APPEAL SUMMARY

Appeal ID: 31978	Project Address: 4626 SE Clinton Street
Hearing Date: 11/15/23	Appellant Name: Tanya Wuertz
Case No.: B-009	Appellant Phone: 303.883.8309
Appeal Type: Building	Plans Examiner/Inspector: Chanel Horn
Project Type: Commercial	Stories: 3 Occupancy: Group R-2 Construction Type: Type V-A
Building/Business Name: Peaceful Villa - Clinton Street Building East	Fire Sprinklers: Yes - as required per NFPA 13
Appeal Involves: Erection of a new structure	LUR or Permit Application No.: 23-035596-CO
Plan Submitted Option: pdf [File 1]	Proposed use: Residential Apartments

Doors from not normally occupied Water Meter Room and Bike Room proposed to open into exterior exit stair of the Clinton East Building: Granted as proposed.

A121A

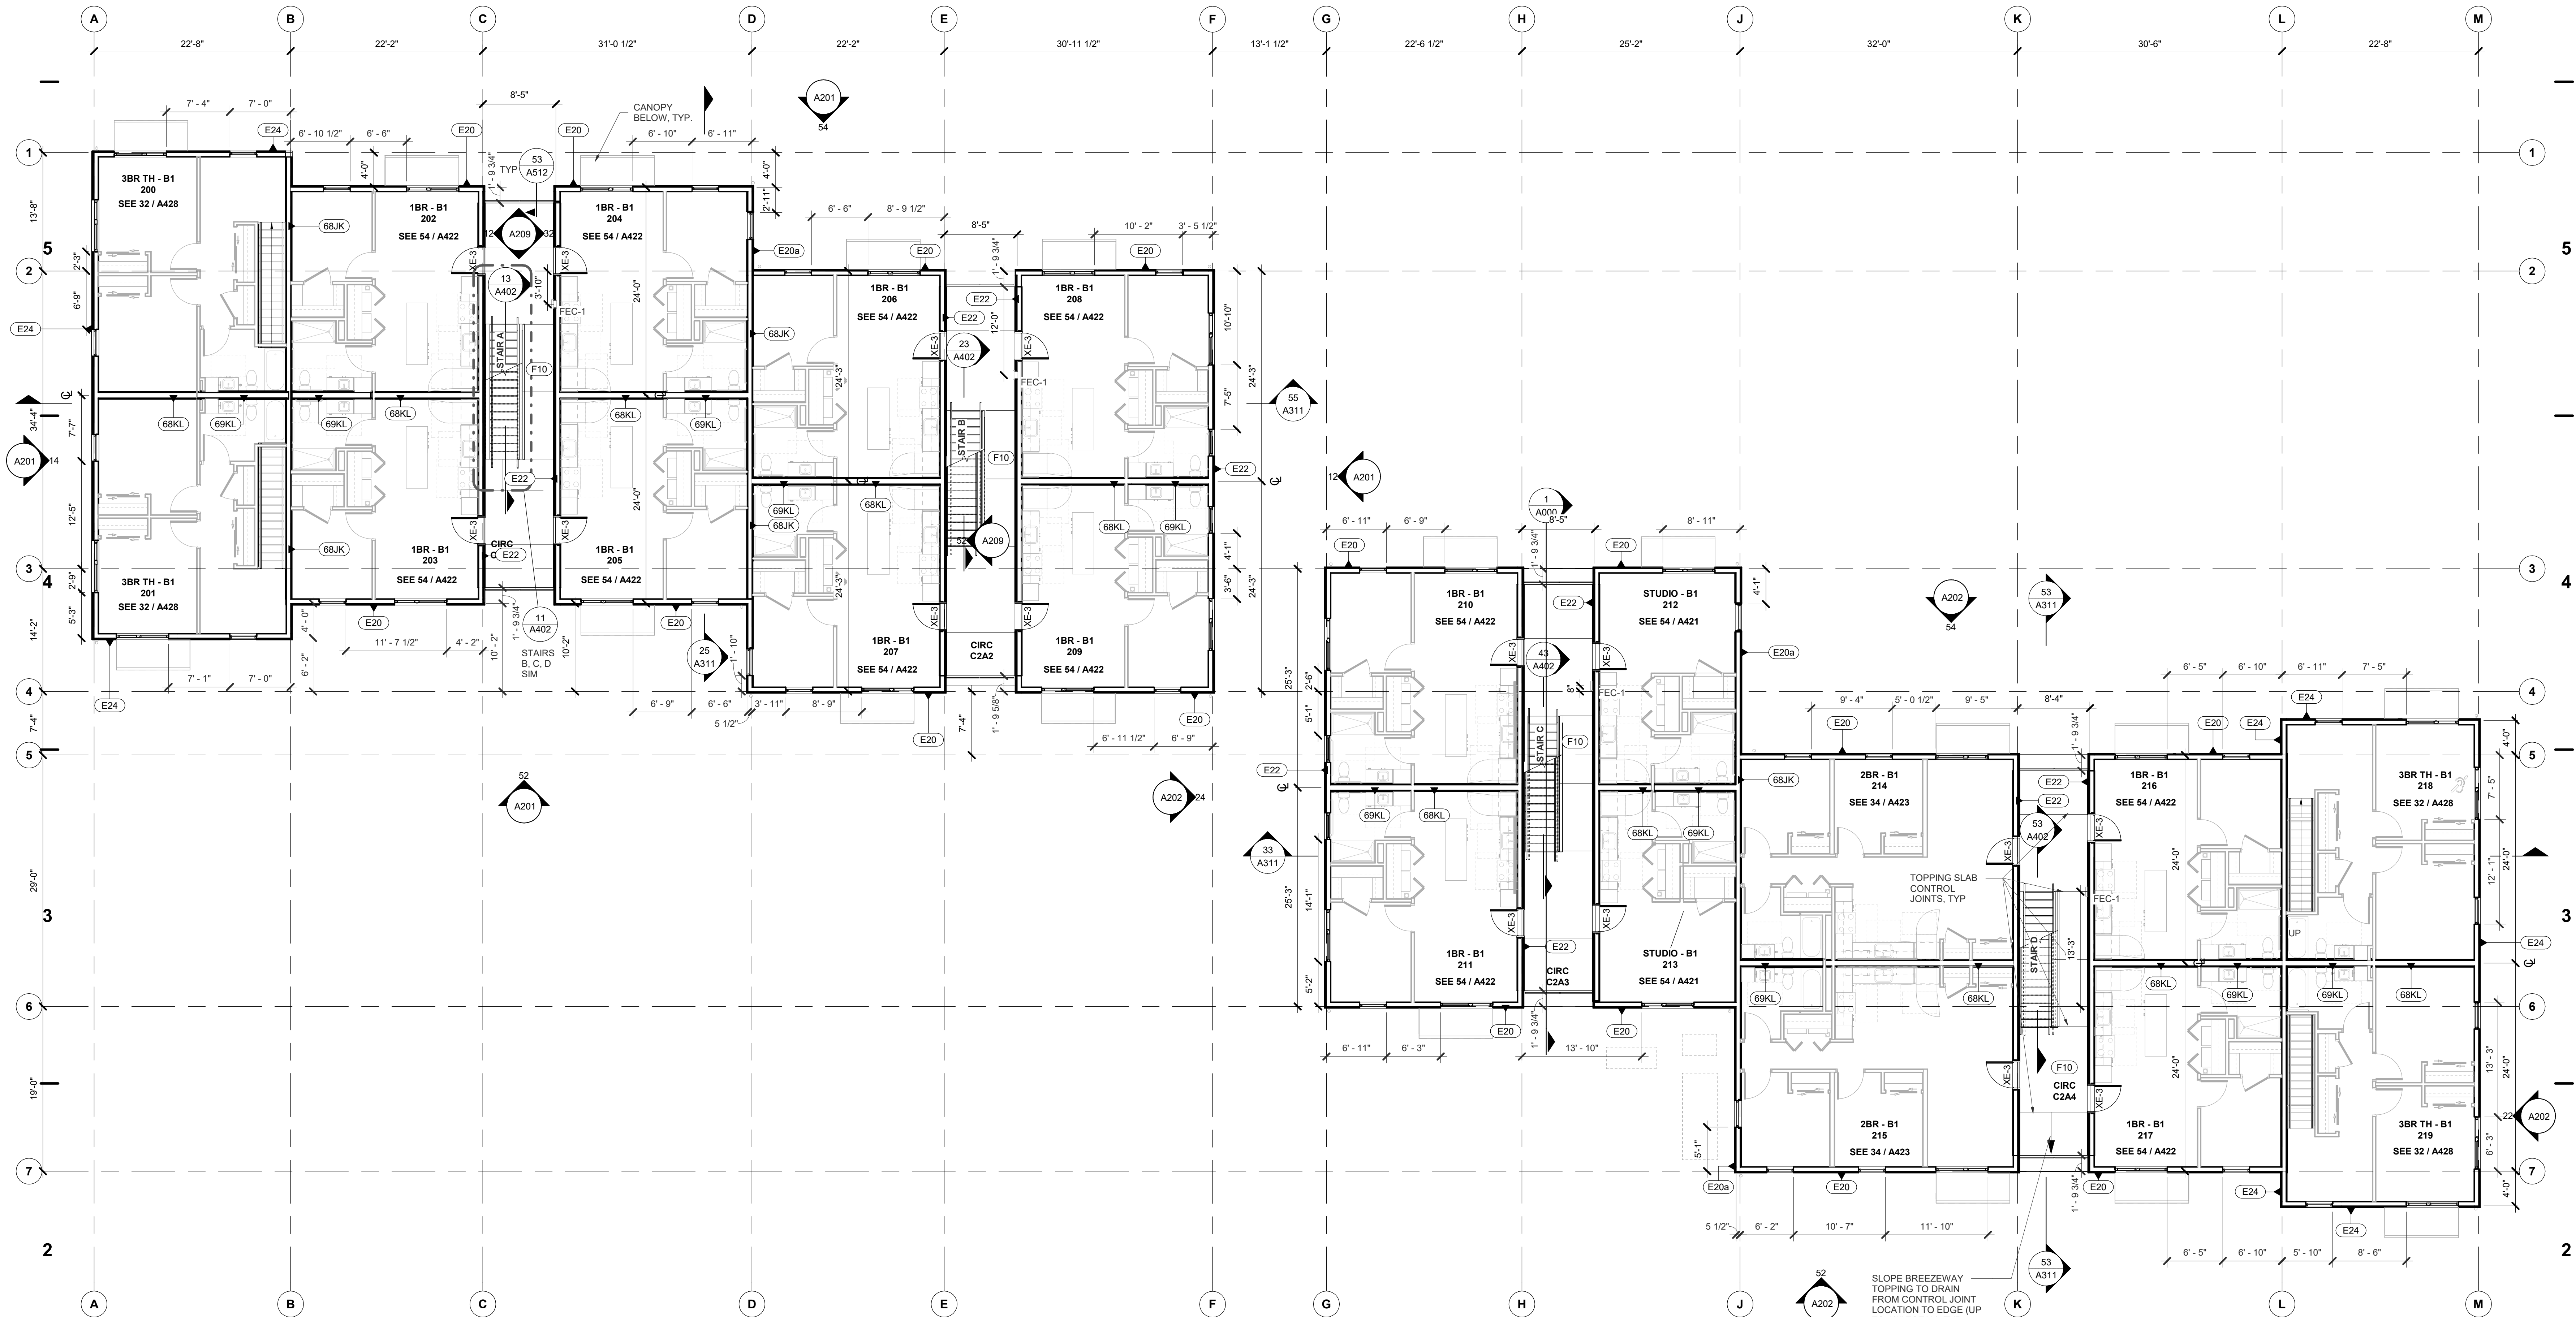
Code Section	2022 OSSC Section 1027.6 Exterior exit stairway and ramp protection.
Requires	"1027.6 Exterior exit stairway ... protection. ...Openings shall be limited to those necessary for egress from normally occupied spaces."
Code Modification or Alternate Requested	The purpose of this appeal is to allow a door opening at the Water Meter Room and the Bike Room located as shown in the west breezeway (CIRC C1A3) that serves to house a single exterior exit stairway at the Clinton East Building.
Proposed Design	Egress occurs from the exterior exit stairway directly to the exterior on the north "egress end", not passing by unoccupied rooms on the south "open end". WATER METER ROOM — Signage stating "NO STORAGE" posted inside the Water Meter Room on wall adjacent to door latch side. BIKE ROOM — Door to the Bike Room is provided with the following:

- o Digital access control and an auto-actuator to provide accessible access.
- o Automatic, self-closing hardware.
- o A vision panel compliant with Table 716.1(2) for opening fire protection (<100 sq. in., D-H-90).

- Only one electrical outlet is provided inside the Bike Room; it will be locked and allowed for use only by maintenance staff.
 - All bike racks are wall-mounted and not appropriate for e-bikes. A Bike Room in another location, outside of the breezeways, is provided for such bikes and their charging requirements.

- Signage stating "NO BATTERY CHARGING ALLOWED" and "DOOR TO REMAIN CLOSED WHEN NOT IN ACTIVE USE" posted inside the Bike Room on wall adjacent to door latch side.

- Sprinkler head located on interior of room centered above door head, designed as a "water curtain" per NFPA 13 (6 ft on-center, 12-in off face of wall).

- 135-degree heat detector, centered in room, and tied to occupant notification appliances located in every unit in the building, common areas, and associated breezeway.

- Occupant notification appliances will automatically activate throughout the notification zones prescriptively upon a sprinkler water flow per Section 907.2.9.1 Exception 2, and/or heat detection trigger added as additional mitigation per this Appeal.

A121A

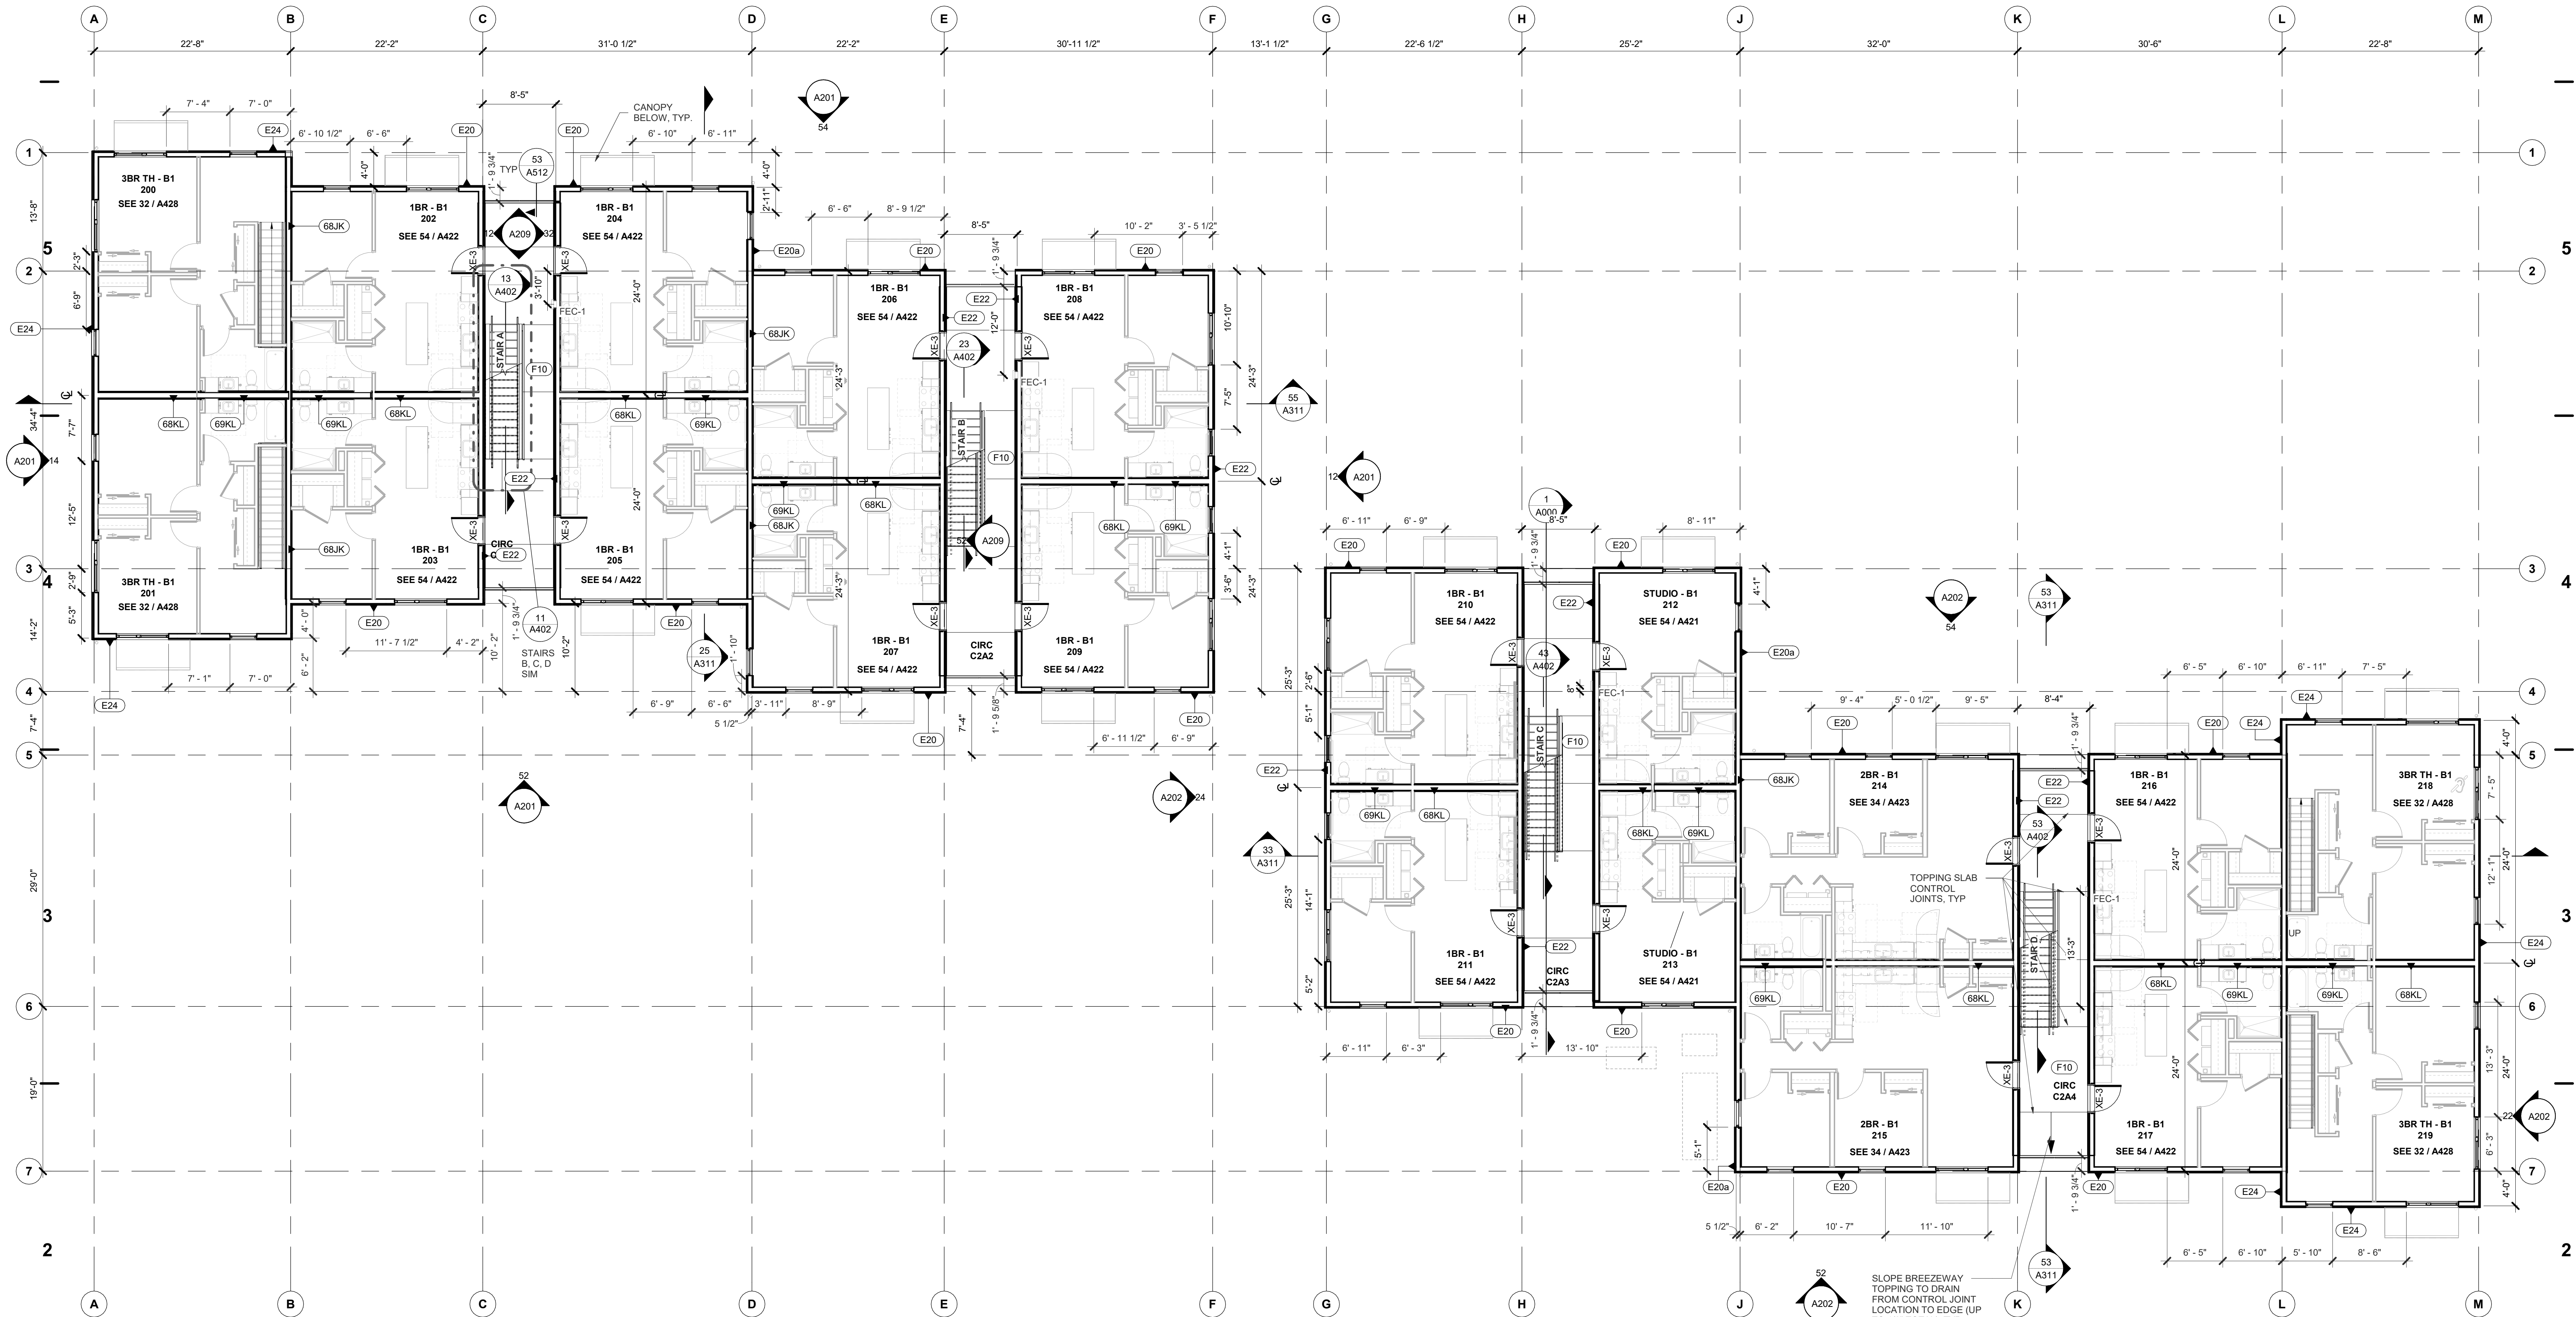
The door at the Bike Room will be provided with digital access control and an auto-actuator for accessible access, as well as automatic, self-closing hardware. This will prevent the door from being propped-open and ensure it is closed during a fire/smoke event. Additionally, a vision panel will aid in viewing potential smoke and fire, which will inform someone of the risk before opening the door during an event that would allow fire/smoke into the breezeway.

Only one outlet will be provided in the Bike Room. The outlet will be locked and only for use by maintenance staff to facilitate maintenance operations. This will ensure that items are not left unattended while charging, particularly bikes. In addition, at the Bike Room, the bike racks are all wall mounted, which is not the typical storage solution for electric bikes due to their weight. Also, a separate Bike Room is being provided at the site that is specifically for electric bikes; it will be provided with appropriate bike racks and adequate power to charge all bikes.

Signage will be provided at the Bike Room to encourage the doors to remain closed. Additional signage at the Water Meter Room will discourage the use of the rooms for storage. At the Bike Room, it will also be stated that battery charging is not allowed. This will provide both the residents and maintenance staff with signage that reinforces the mitigation measures identified in this appeal to support the safe egress of all occupants.

At the Bike Room an additional sprinkler head will be provided at the interior of the room, above the door. Designed as a "water curtain" per NFPA 13, it will suppress any fire that originates within the room, thus protecting the opening beyond the increased fire-resistance rating of the door. As well, one (1) 135-degree heat detector will be provided in each room. This will be tied to the notification appliances (horns and strobes) that are provided as required in each unit; additionally, a fire alarm notification appliance will also be provided at each breezeway where these openings occur. This early warning detection will allow occupants to be alerted earlier than normal to initiate egress; it provides a trigger at 135

degrees, as opposed to the 155 degrees required to fuse a sprinkler head. Additionally, if triggered at the same time, the heat detector provides notification 30-90 seconds before the fire sprinkler water flow device due to the inherent delay with flow switch verification.
